DUKE POWER COMPANY

August 30, 1982

Re: Catawba Nuclear Station
Docket Nos. 50-413 and 50-414

Ms. Elinor G. Adensam's letter of June 9, 1982 transmitted five additional questions from the Mechanical Engineering Branch. Attached are Duke Power Company's responses.

Figure 27A. Letdown Line Flowrate Increased by 60% and then Reduced Back to Normal

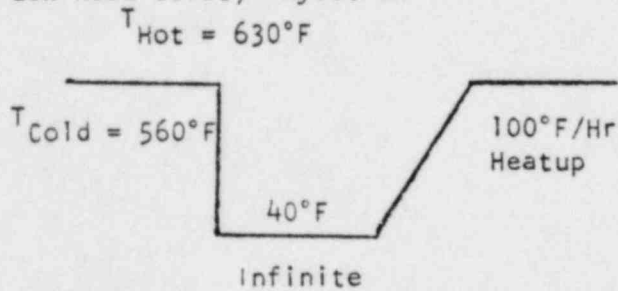
- c. Letdown line flow rate increased by 60 percent and then reduced back to normal.

INT numbers indicates that the temperature of the charging line is increased by 30°F. Use 50°F for design purposes. See Figure 27A.

Figure 27B. Letdown Line Flowrate Decreased by 50% and then Increased Back to Normal

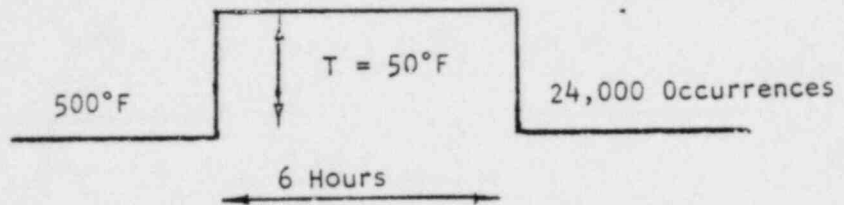
- d. Letdown line flow rate is decreased by 50 percent and then reduced back to normal.

INT numbers indicates that the temperature of the charging stream decreases by 95°F. Use 125°F for design purposes. See Figure 27B.
